Documentation Changes

The following documentation changes pertain to your VS1 transmitter, as of DWA-320 being implemented at the factory. Implement these changes into your existing electronic or paper documentation as desired.

DWA-320 – Manual Replacement Page

Table 1: Power Supply Interface

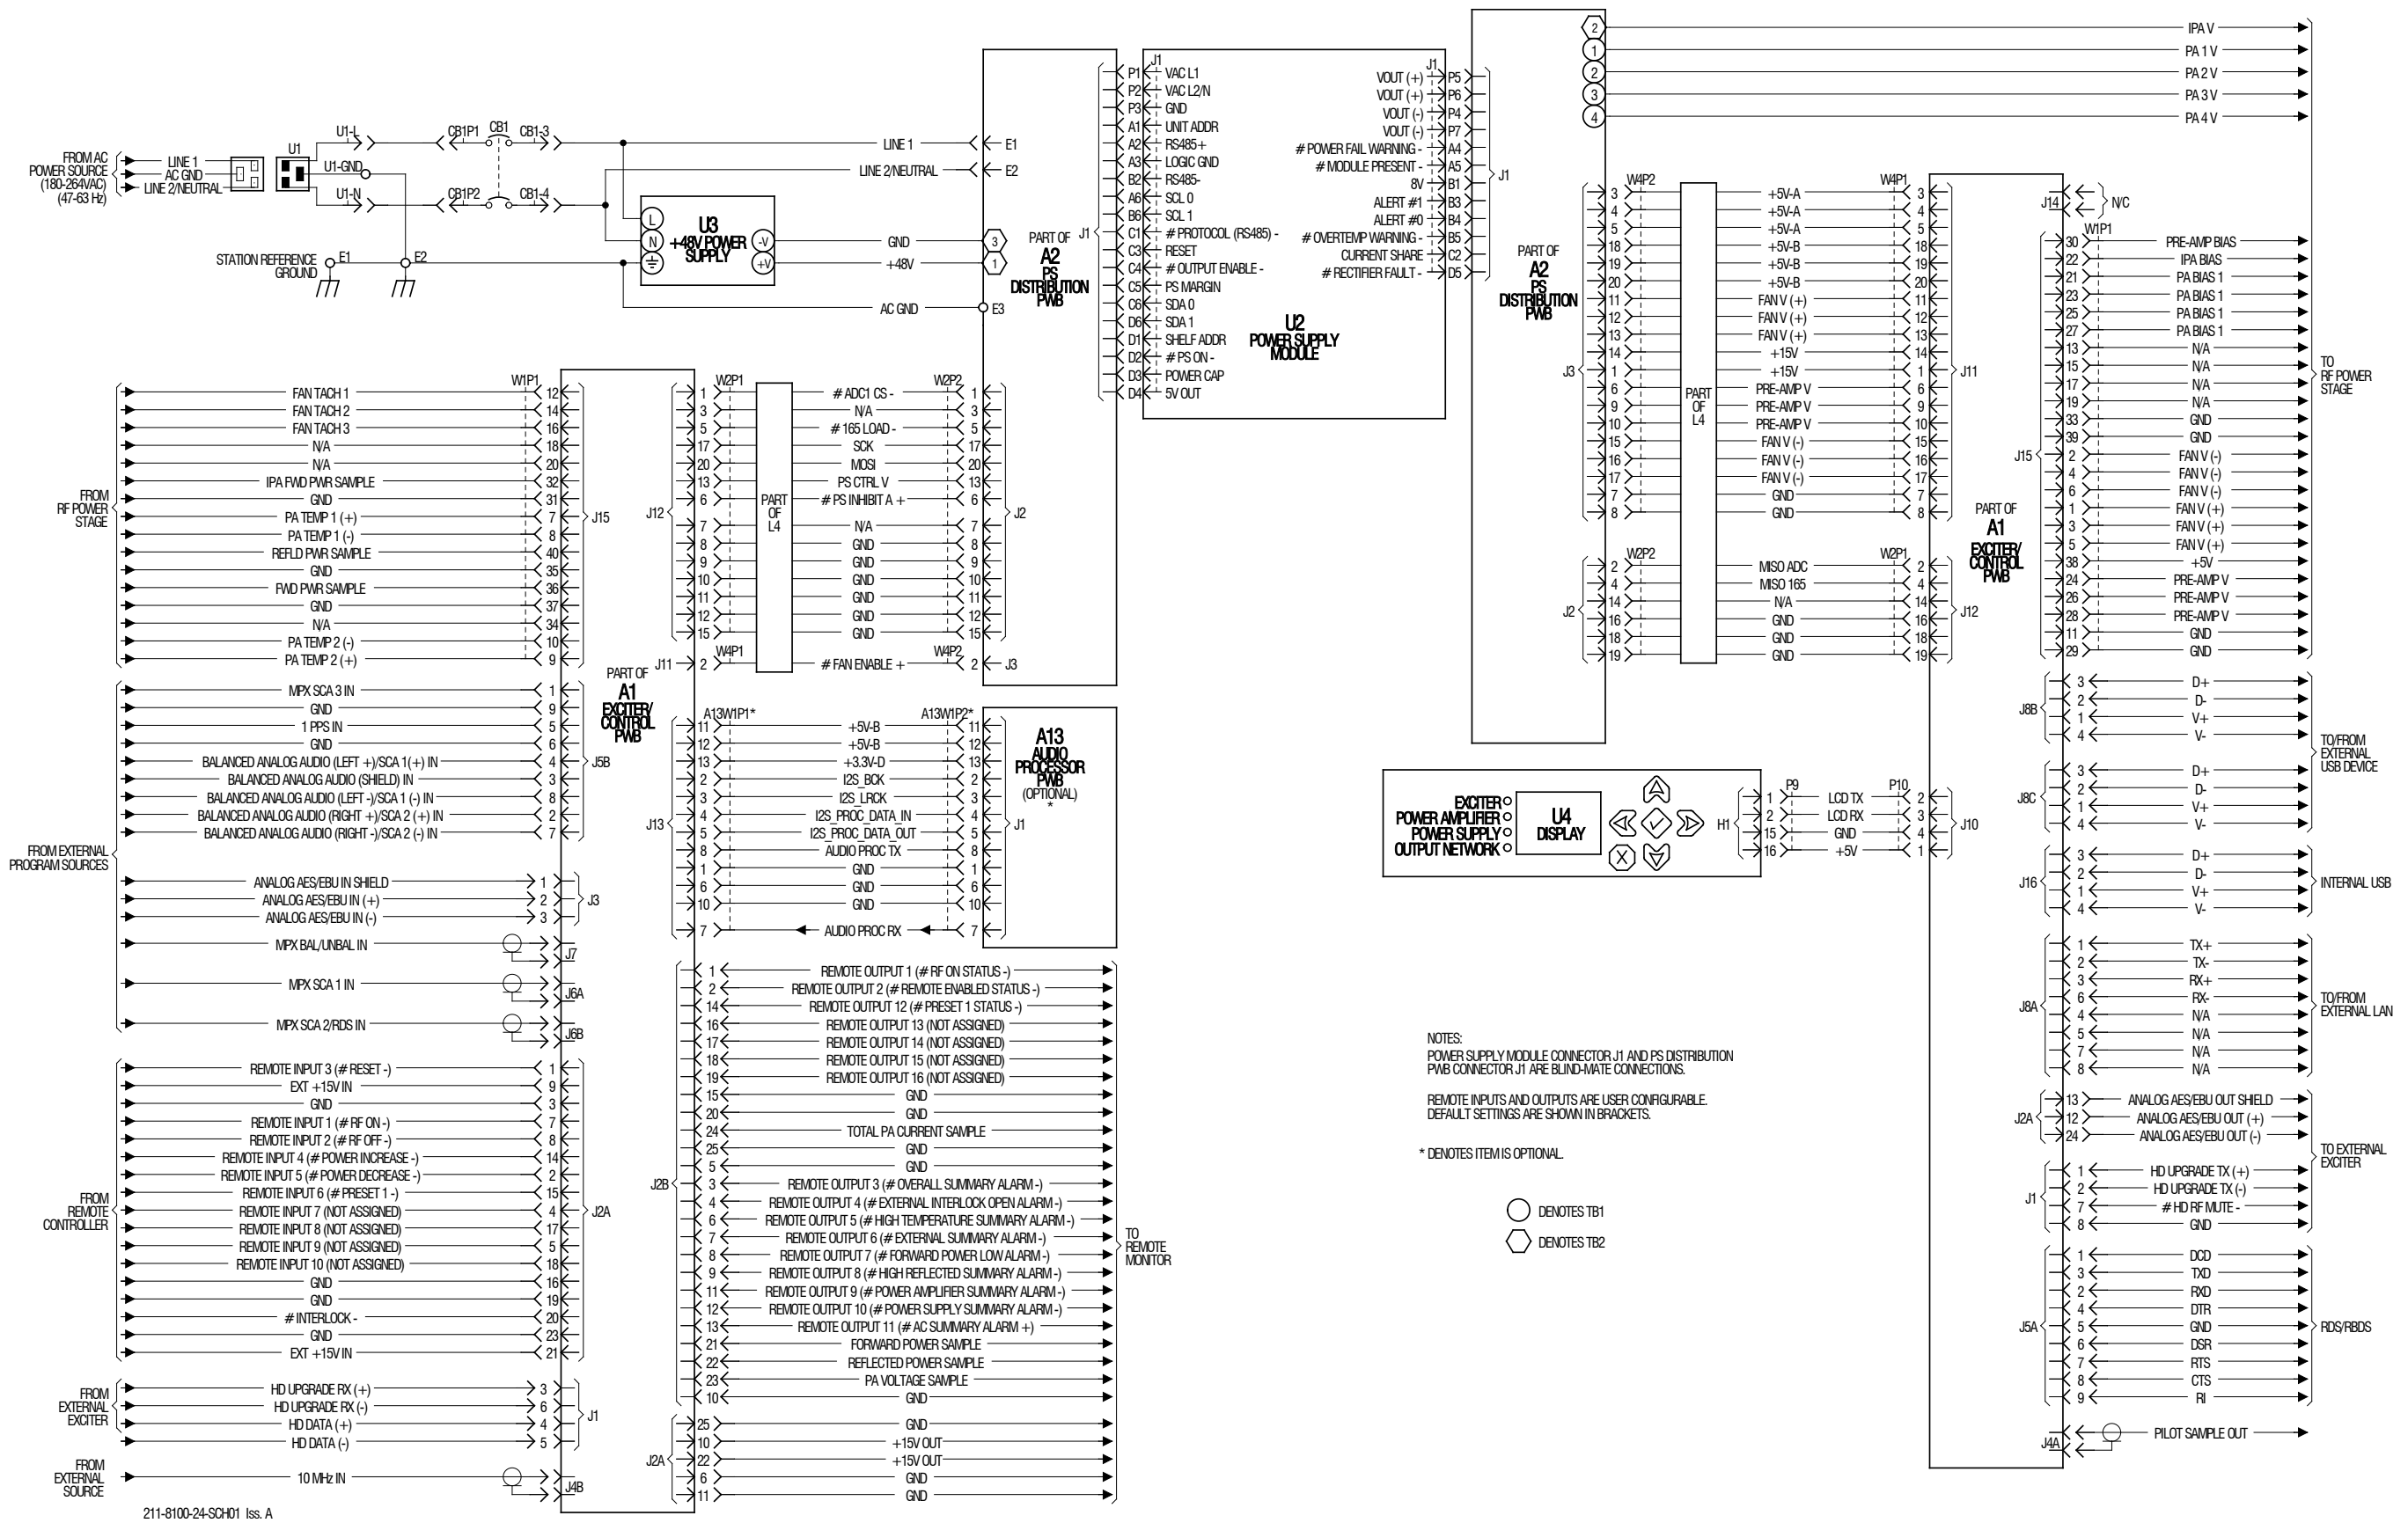
The power supply module has changed from UG69* to UG132. The front panel interface for the power supply module differs as shown in Table 1.

Figure SD-1

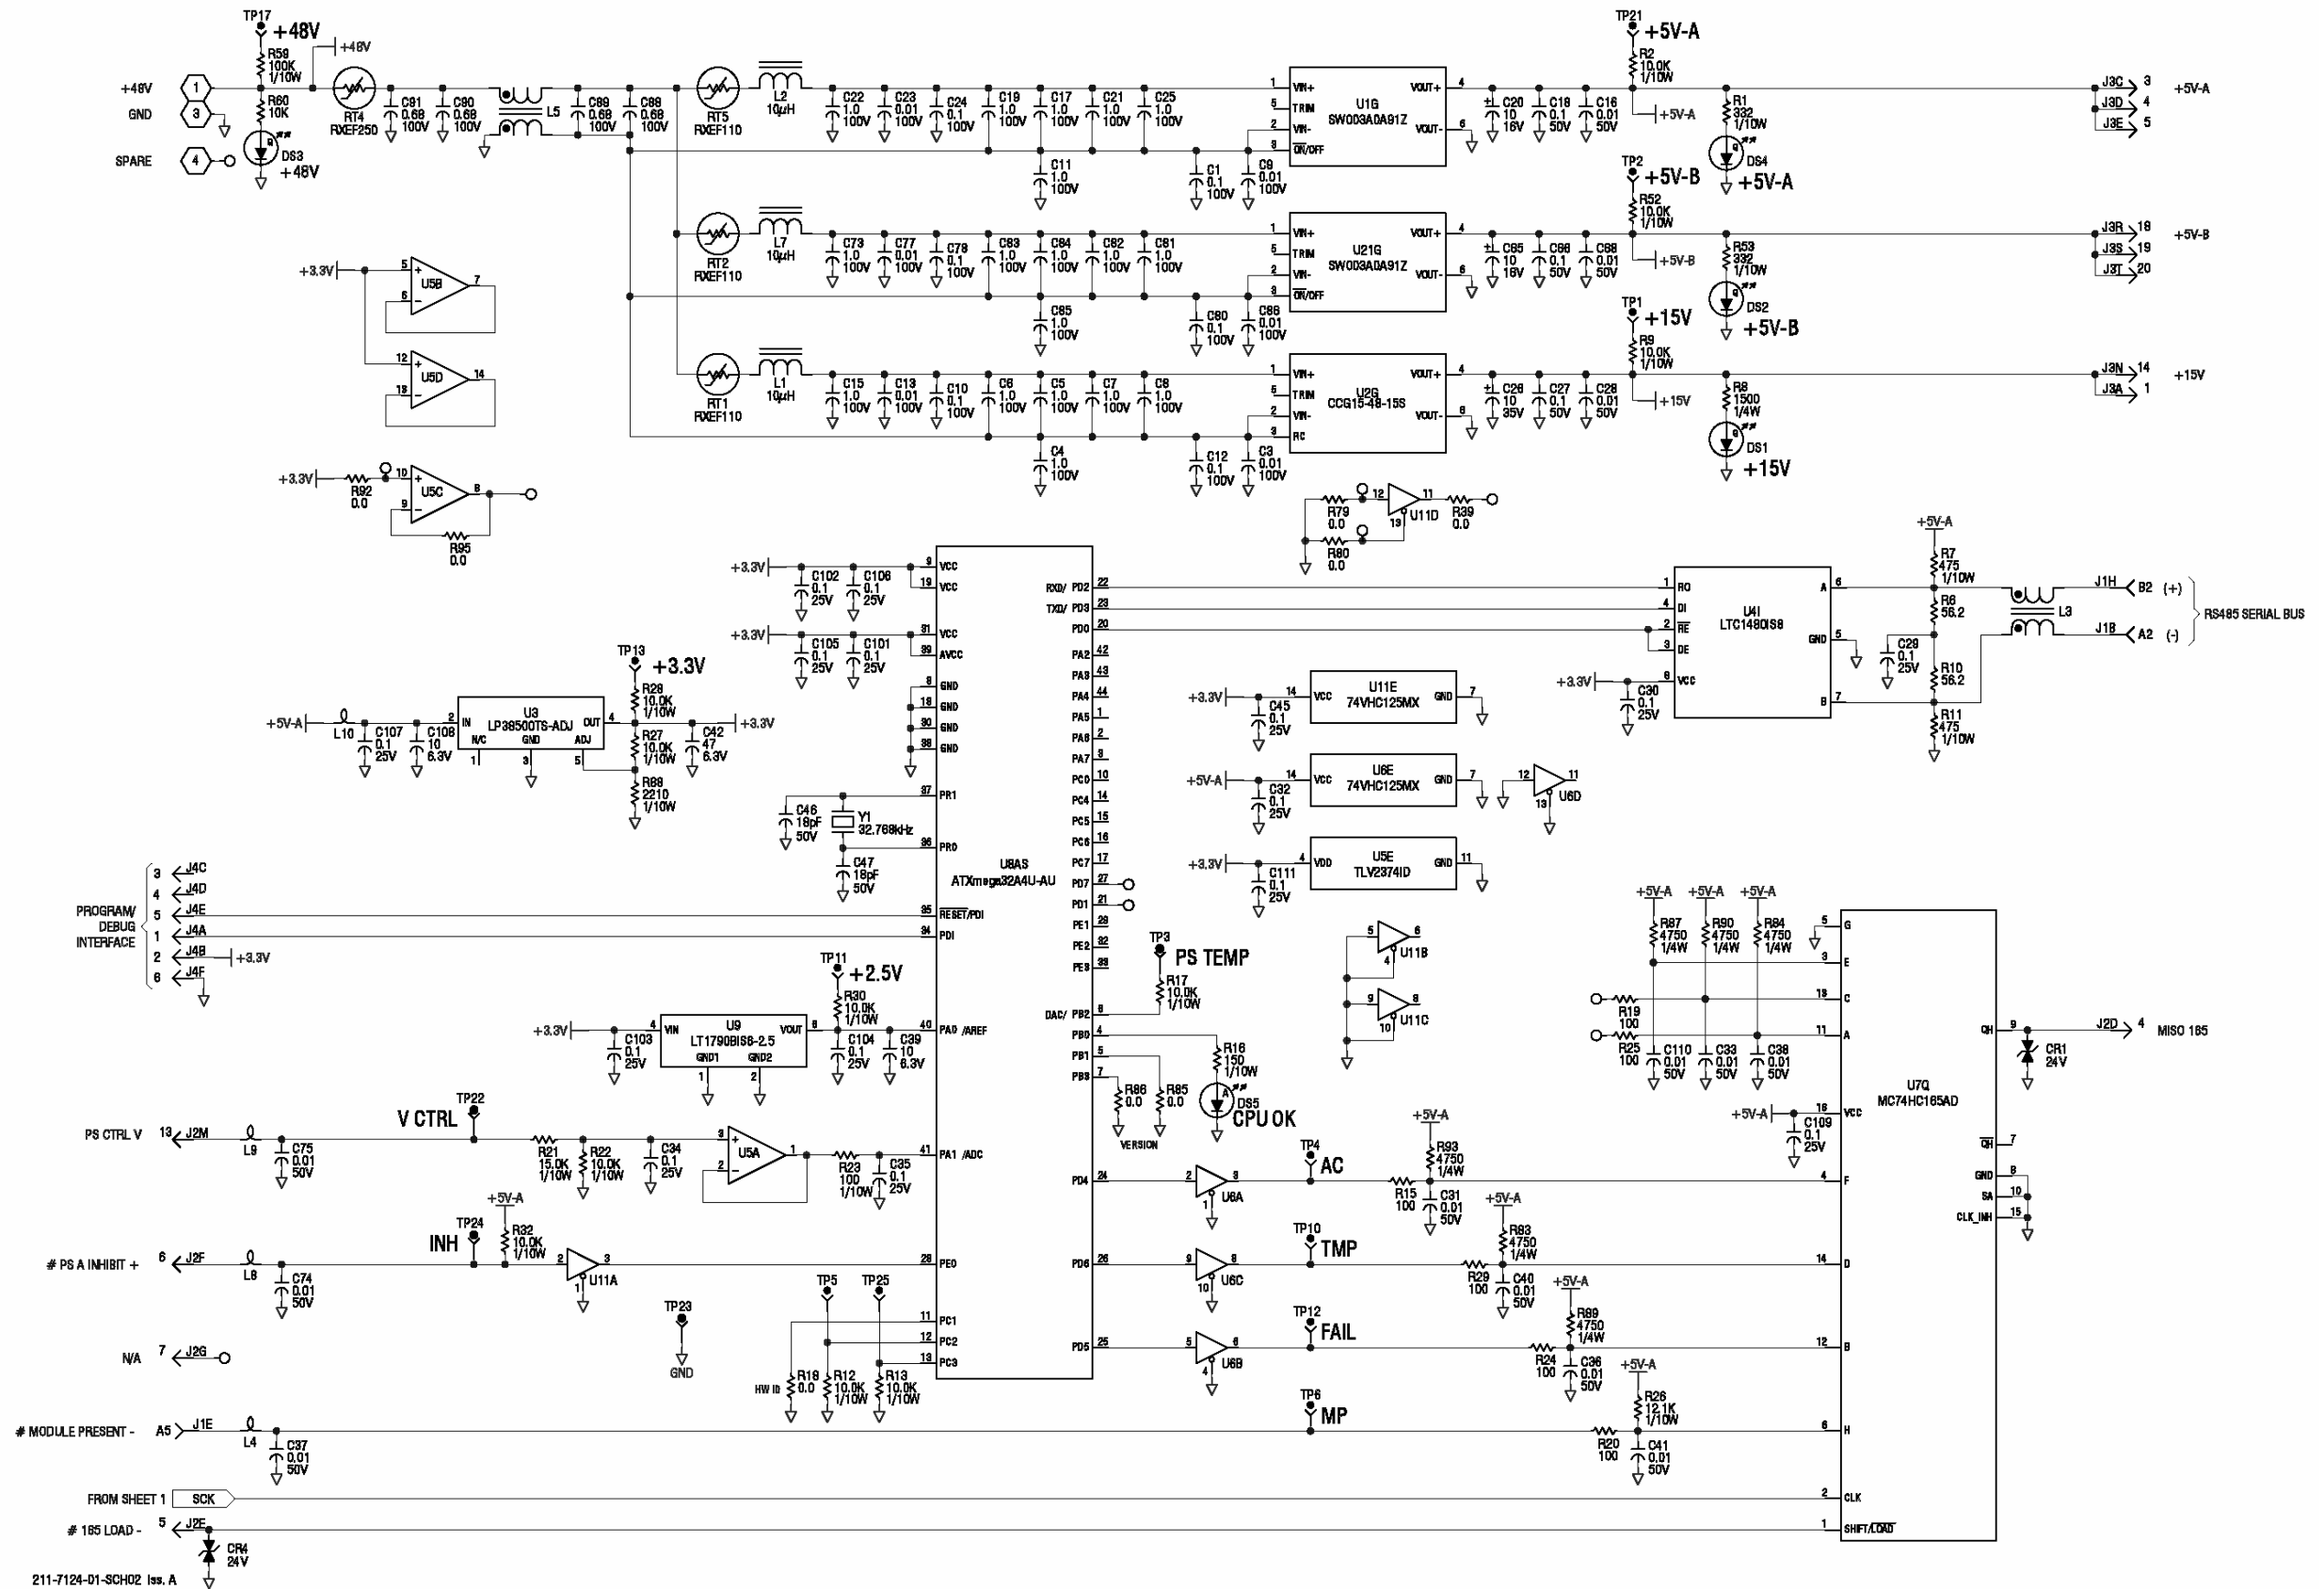
The +7-53 Vdc Power Supply (U2) has been changed from Nautel part # UG69* to UG132. The Power Supply Distribution PWB (A2) has been changed from Nautel part # NAPS41* to NAPS57A. These changes affect the technical documentation, particularly the following sections of the VS1 Troubleshooting Manual:
